U.S.A. RECALL CAMPAIGN NO. 49

Ferrari F430 Spider Vehicles

Installation of heat shields for convertible top hydraulic lines.

SUBJECT: Recall Campaign No. 49

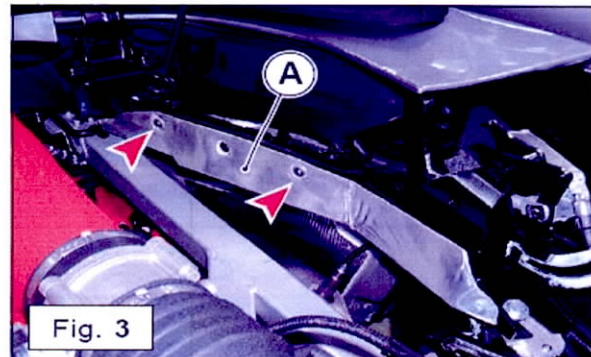
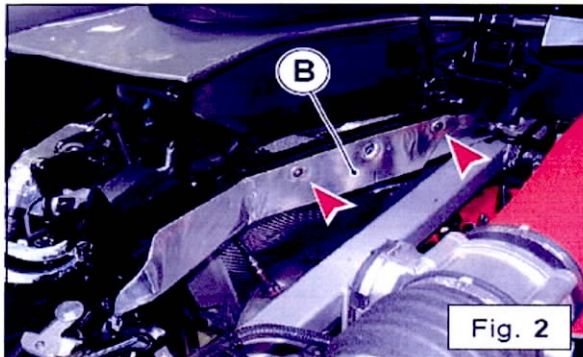
1) Install the heat shields in the engine compartment over the hydraulic lines of the convertible top system. (Fig.1, kit part no. 70001320).

This operation is required in order to prevent possible leakage of the hydraulic fluid for the convertible top.

- I.** Remove the L/S and R/S engine compartment trim covers (following the procedures described in section M2.13 of the Repair Manual).
- II.** Inspect all of the hydraulic lines for any signs of leaks or overheating and replace if necessary.
- III.** Position the insulating shields under the R/S and L/S cross members of the convertible top support frame. (A and B, Fig's 2 and 3)
- IV.** Install the screws and washers to secure the insulating covers into the holes that are already located on the cross members.
- V.** Reinstall the L/S and R/S engine compartment trim covers.
